**Draft Recommendation for  
Space Data System Standards**

**RADIO FREQUENCY AND  
MODULATION SYSTEMS—  
PART 1: EARTH STATIONS  
AND SPACECRAFT**

**CCSDS 401.0-P-17.1**

**PINK SHEETS**

**Figure 2.4.20B-1: GMSK Precoder**

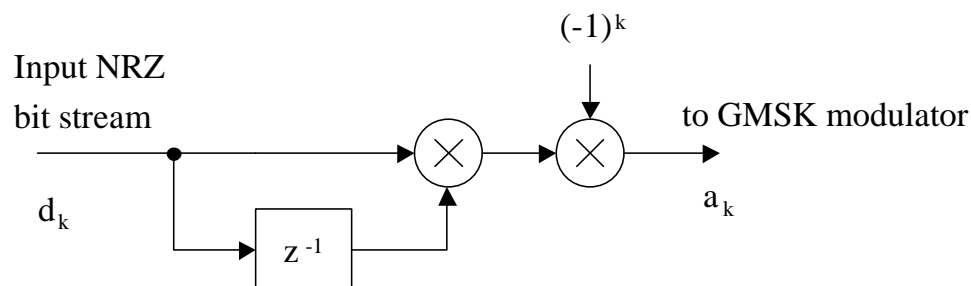
- (1) that GMSK ( $BT_s = 0.5$ )<sup>2</sup> be used for high data rate transmissions whenever practicable at symbol rates below 20 Ms/s and in any case for rates equal to or in excess of 20 Ms/s in communications systems operating in the 32 GHz bands;
- (2) that CCSDS agencies use a data randomizer as specified in the CCSDS Recommended Standard, *TM Synchronization and Channel Coding*, CCSDS 131.0-B-1 (or latest edition).

<sup>2</sup> Gaussian Minimum Shift Keying ( $BT_s = 0.5$ ), with precoding as in figure 2.4.20B-1. See CCSDS 413.0-G-1.
